Review of Groundwater Issues Associated with the Proposed Bylong Project

Independent Planning Commission NSW

Dr Lloyd Townley

5 March 2019

Figure 11: (a) Groundwater users and entitlements, (b) locations of bores and wells from census, (c) Bylong Valley Landholdings and (d) maximum drawdown in the alluvium (base case), from Figures 7-4 and 7-6 in AGE (2015), Figure 3-6 in AGE (2017) and Figure 1 in AGE (2018b), respectively

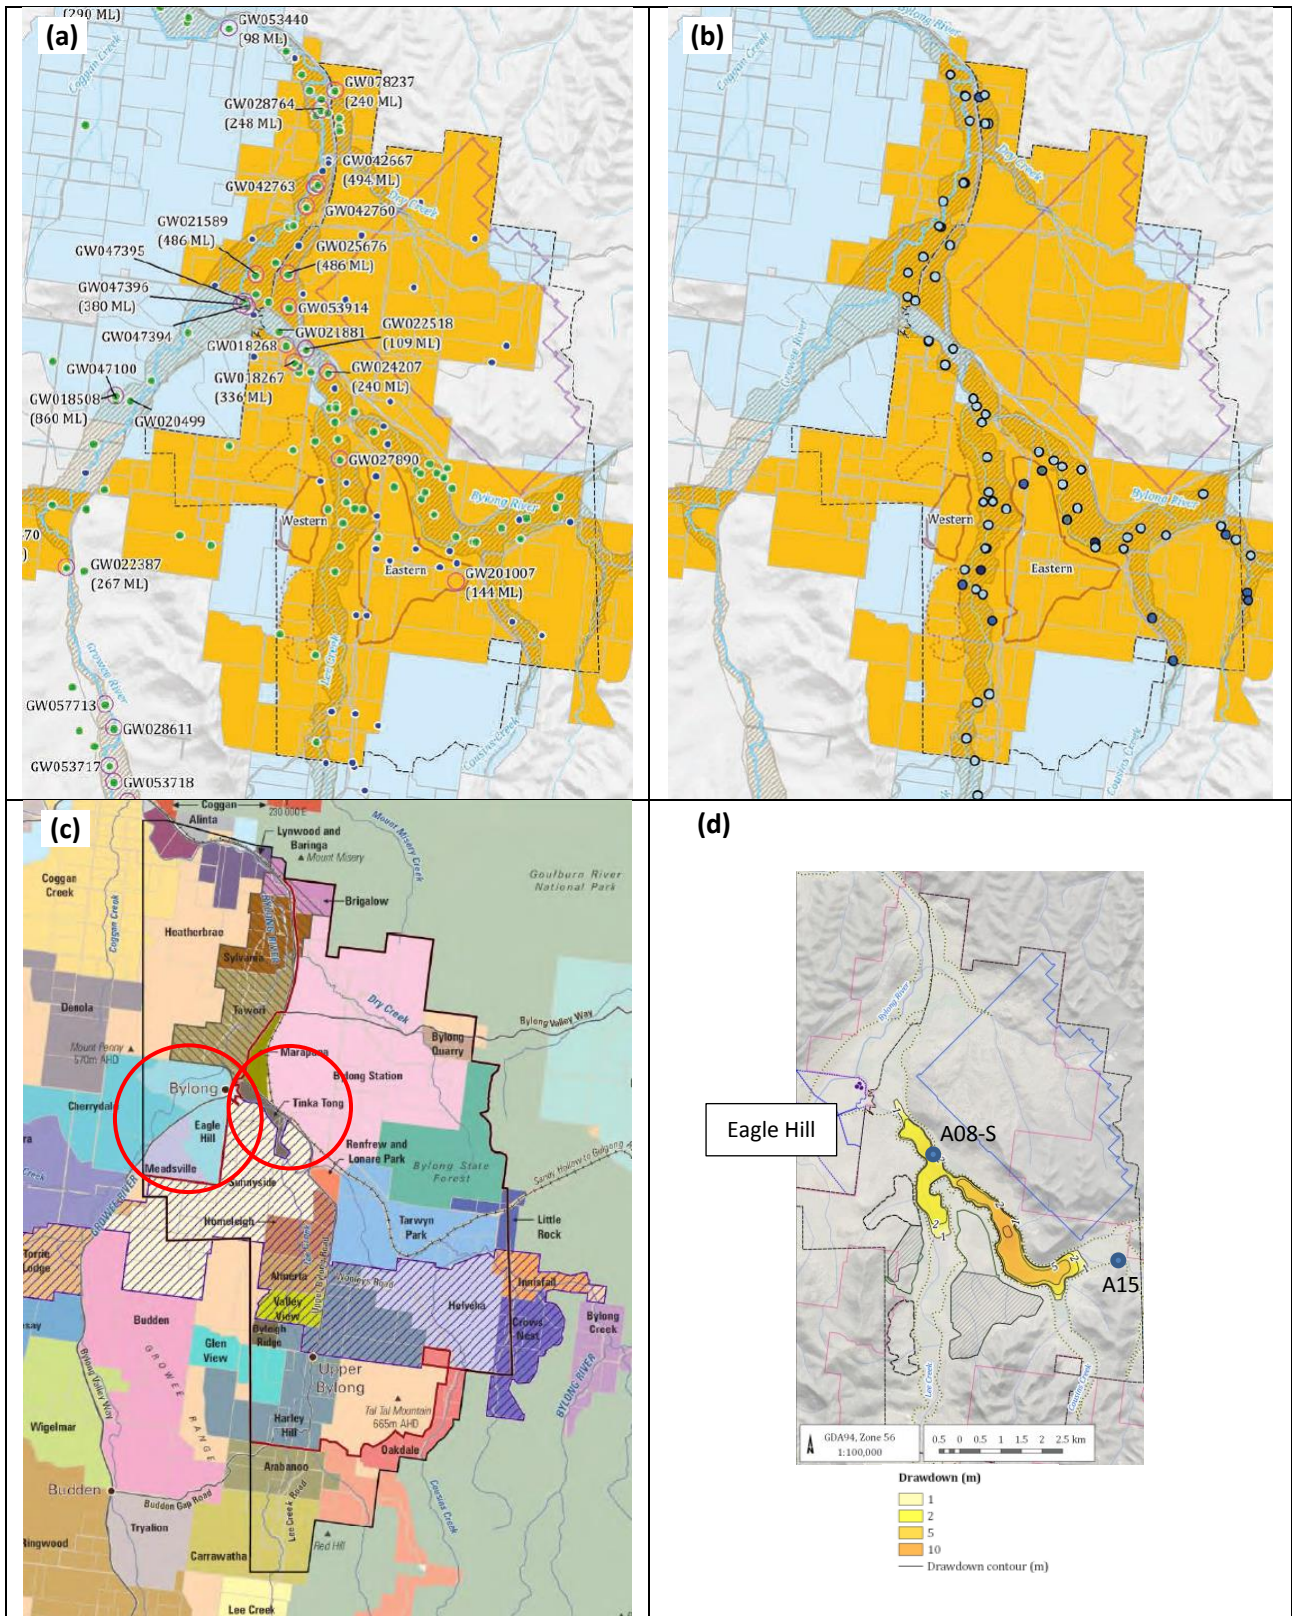
It is useful to discuss the meaning of drawdown plots. First, Figure 11(d) shows maximum drawdown, but the same drawdown does not occur at the same time at all locations. Second, it is tempting to visualise a cone of depression as “hole” or low point in the water table, but in fact drawdown must be superimposed on the pre-mining water table in the alluvial aquifer. As explained in Section 4.2.1 above, the water table in the Bylong River alluvium drops 30-35 m over a distance of 5.3 km, from upstream of the mining-affected area to the confluence of Lee Creek and Bylong River. At an unspecified time, when drawdown is 10 m at a location between the eastern open cut mine and the longwall mine, the water level would be 10 m lower roughly halfway between A15 and A08-S, so the rate of flow in the alluvium would be faster from A15 towards that location, and slower between there and A08-S.

The impact of drawdown on bores within the affected area is not completely clear. To see the details, it would be necessary to examine model output in other ways, looking at long-sections at different times, and examining the water balance of the alluvial system. Figures 7-1 to 7-4 in HS (2016) are a good way to visualise the alluvial aquifers. It is not clear whether the water table is in layer 2 or 3 of the model at the time of maximum drawdown. Nevertheless, the fact that maximum drawdown of 1 m is not predicted to extend to the confluence of the Growee and Bylong Rivers suggests that the Applicant is right to believe that there will be no effect on irrigation bores in the Eagle Hill property.
